**Re: 648, 670, 686, & 690 Pacific Street, and 171 Henry Street**  
**ZB 221-29 – Zoning Board Comments**

In response to comments and requested supplemental information during the hearing on 1/24/22, we are submitting the following materials as described below:

**PROPOSED COVERAGE EXHIBIT**  
**648, 670, 686 & 690 PACIFIC STREET AND 171 HENRY STREET**  
**STAMFORD, CT**

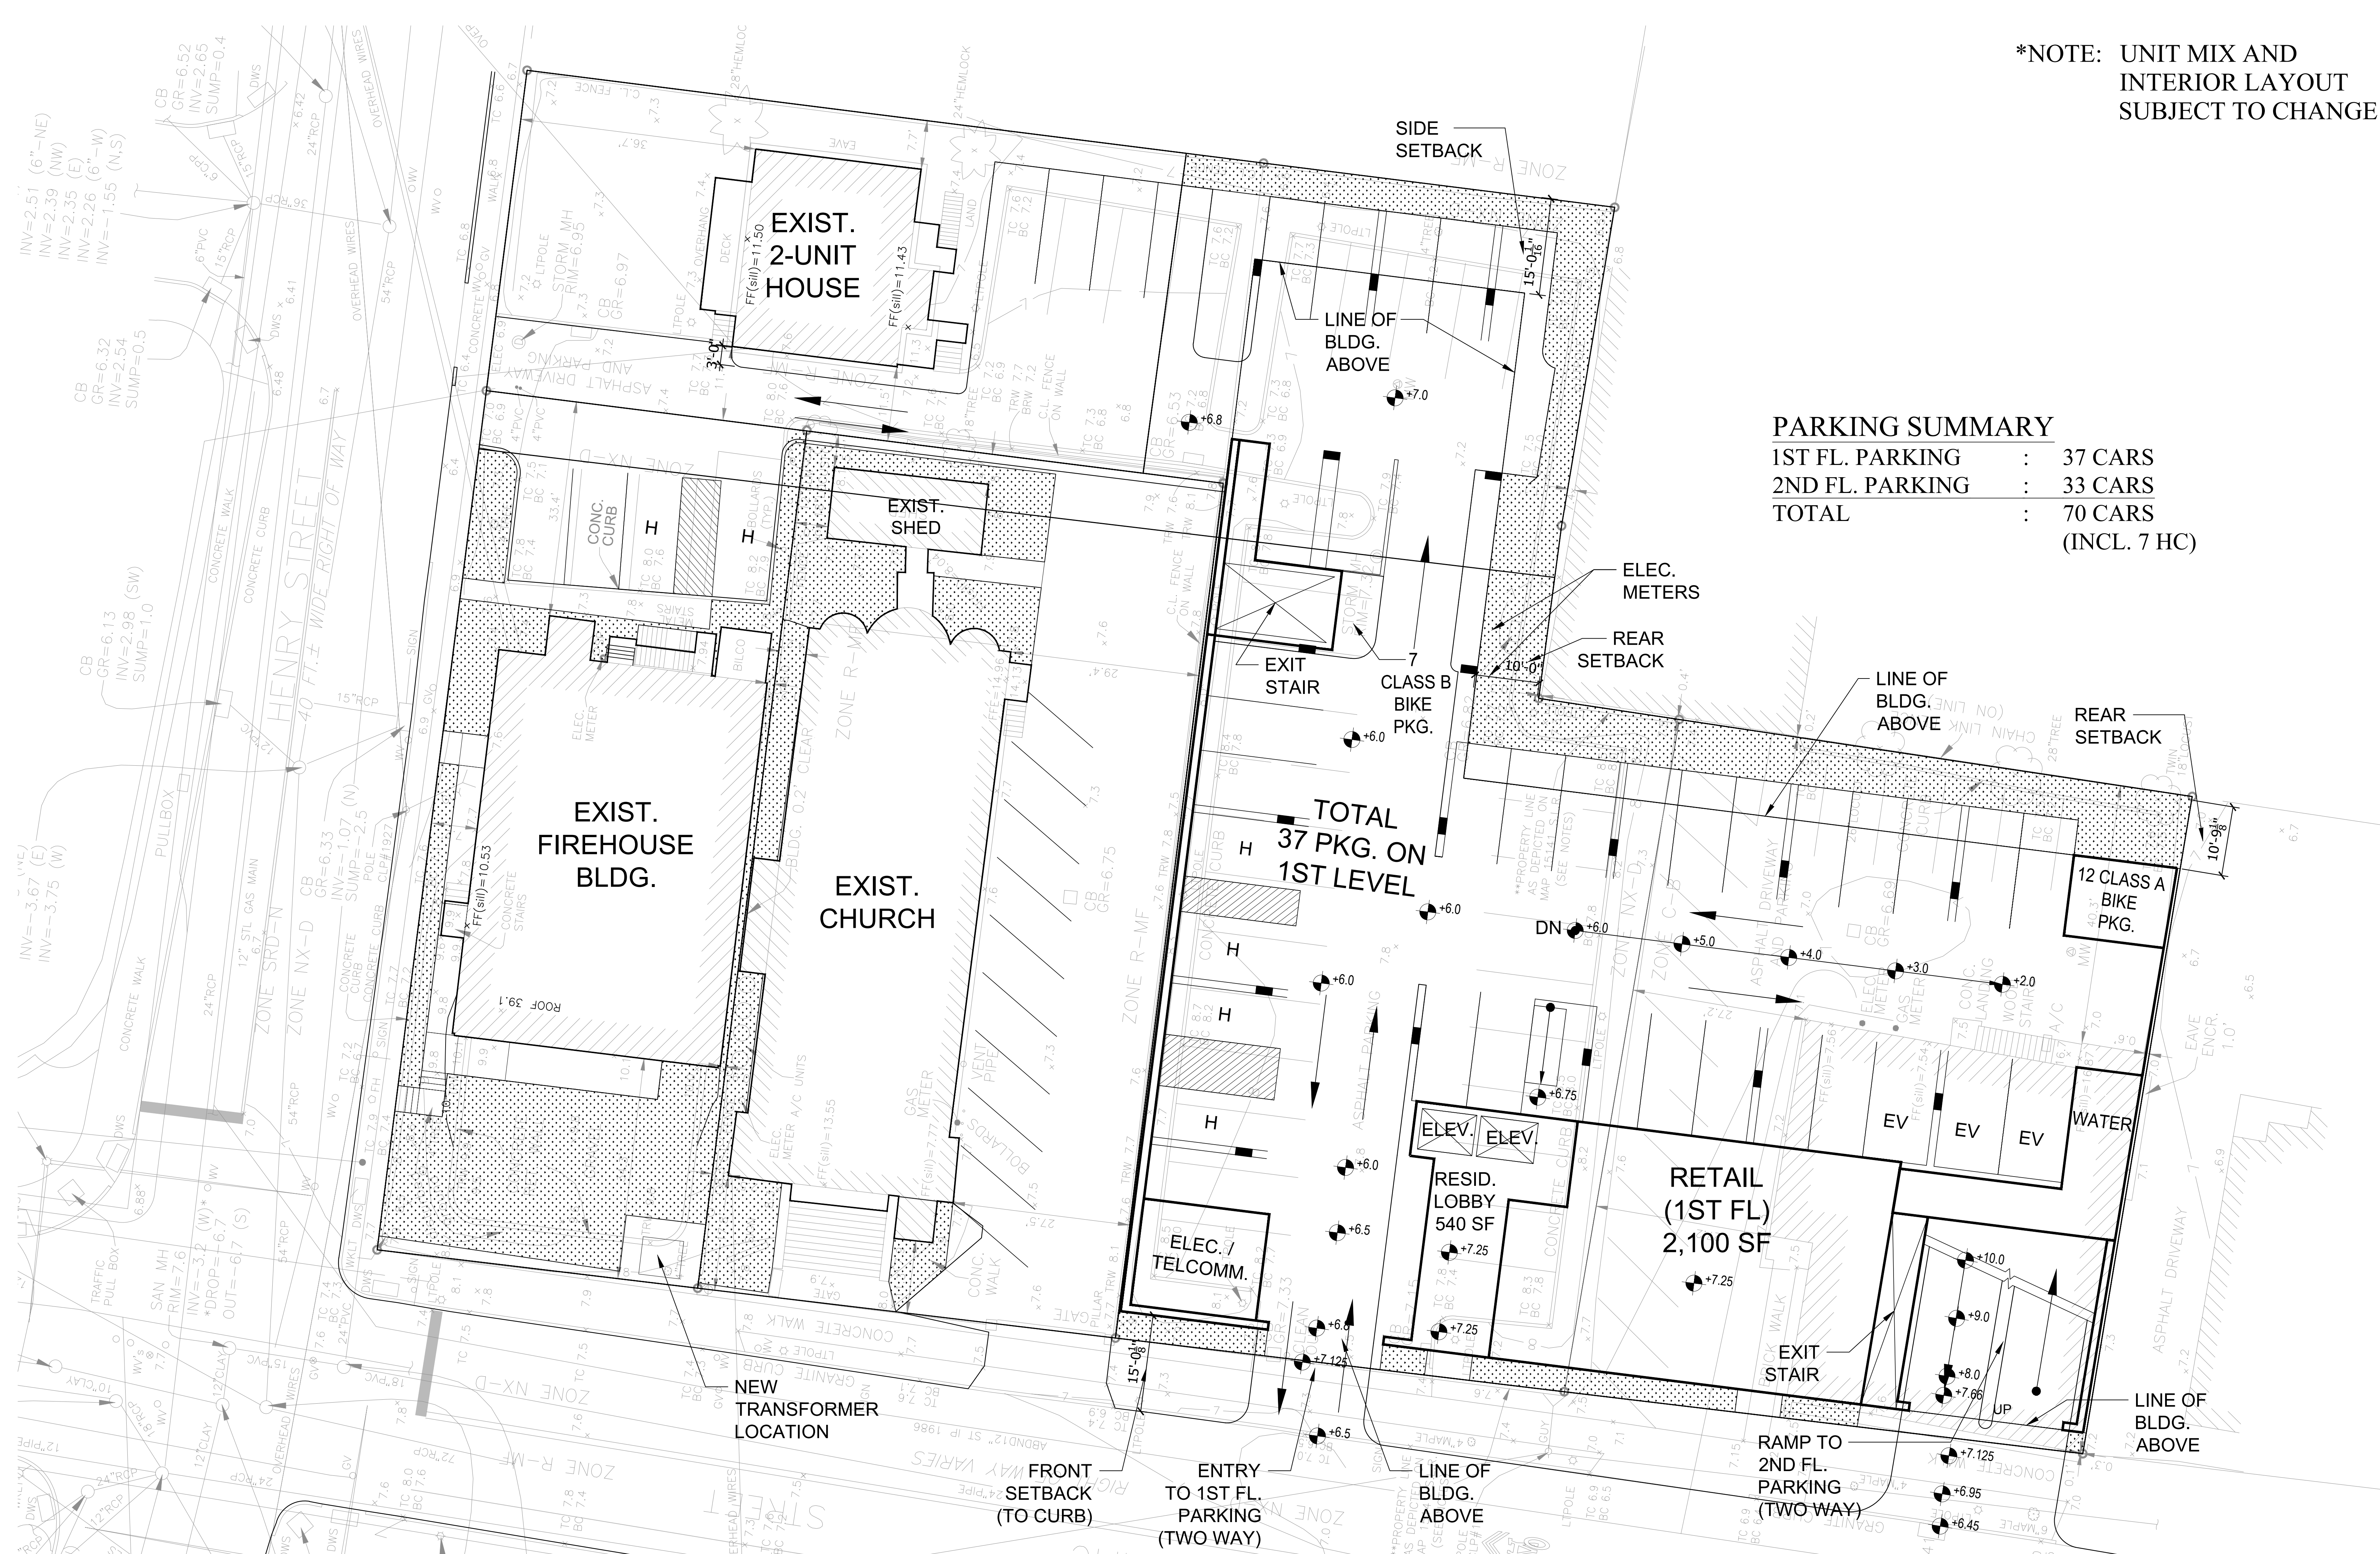
The proposed site plans have been updated so that each parcel within the overall Zoning Lot complies individually with the minimum pervious area requirement of 15%. The parcel containing the proposed building has been revised to include the use of pervious pavement to meet the requirement without any “allocation” from other parcels. The “firehouse” lot has also been updated to include a front patio area. Overall, pervious areas on the Zoning Lot were increased from 15.2% to 16%. **See updated Proposed Coverage Exhibit.** Changes are also reflected on the landscape plans and zoning charts.

**1 FRONT ELEVATION @ PACIFIC STREET**  
1/8"=1'-0"

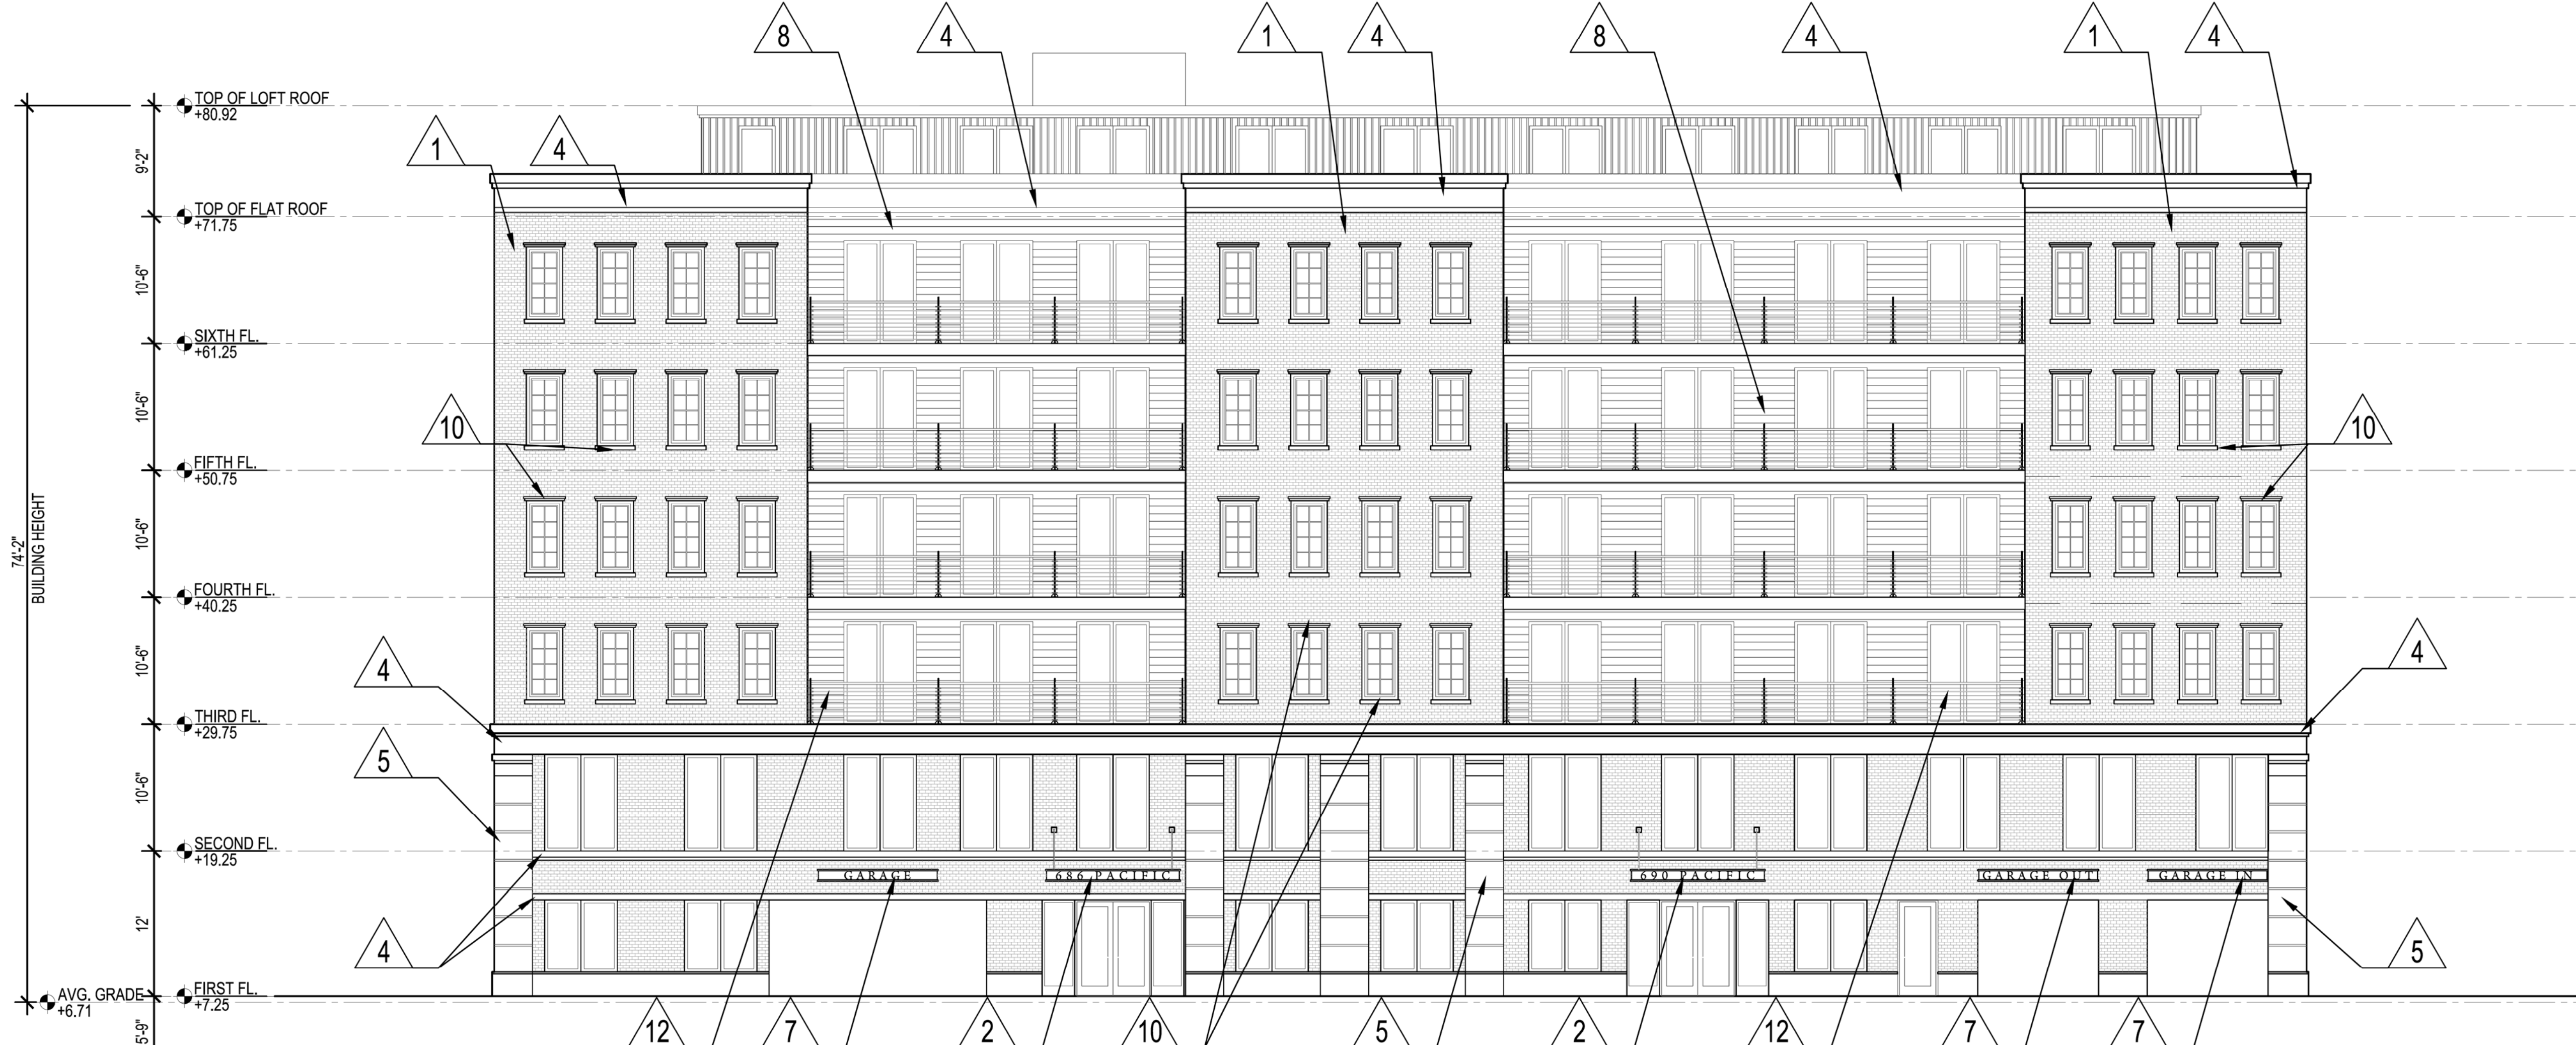
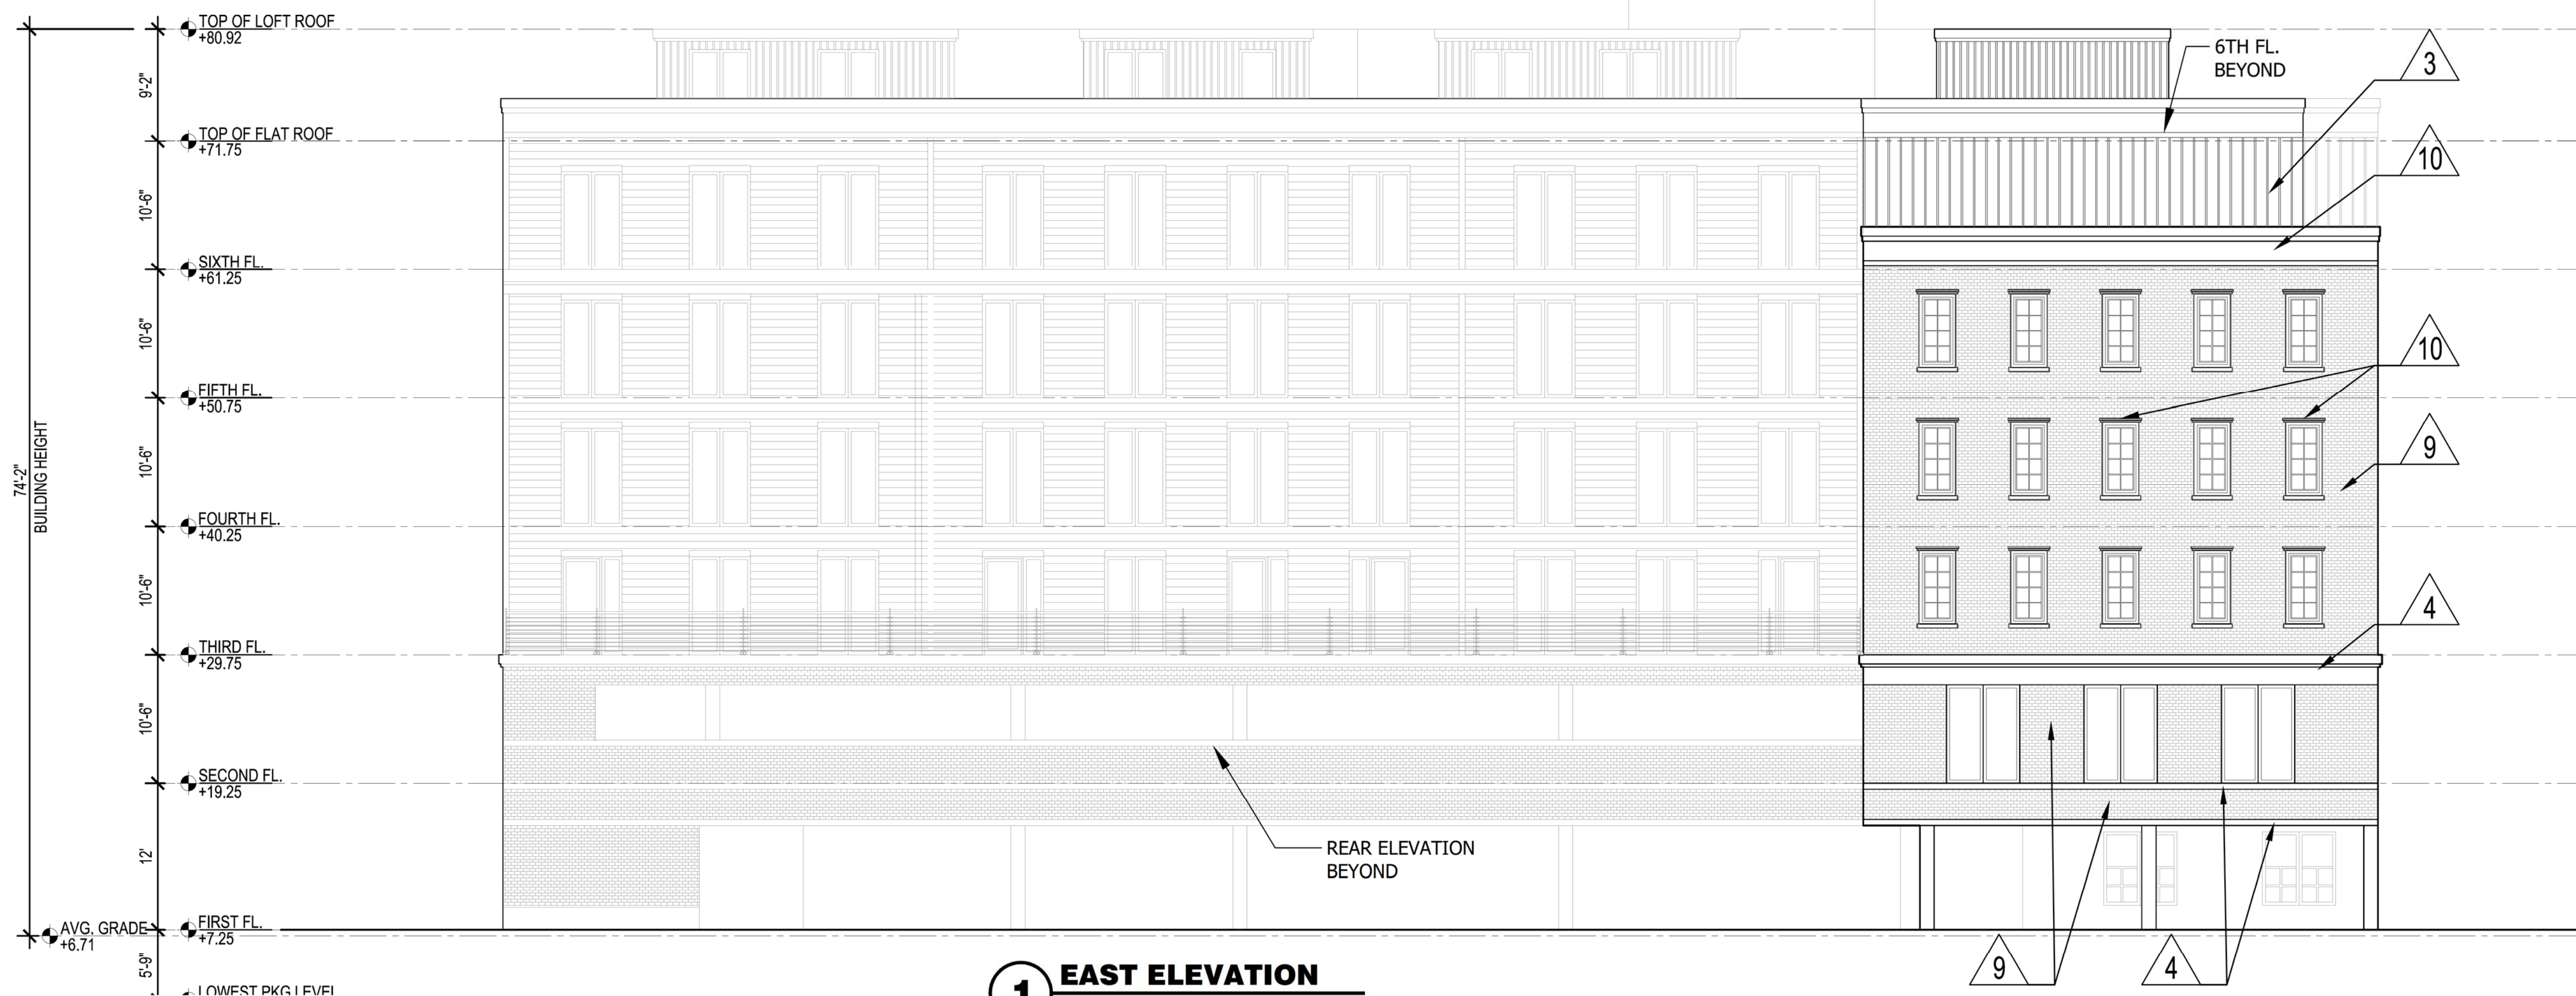
The proposed building materials have been updated to replace vinyl siding with fiber cement (e.g. Hardie Board) on the west (facing Pacific St.) and north (facing Henry St.) building facades. **See revised architectural sheet A-210.**
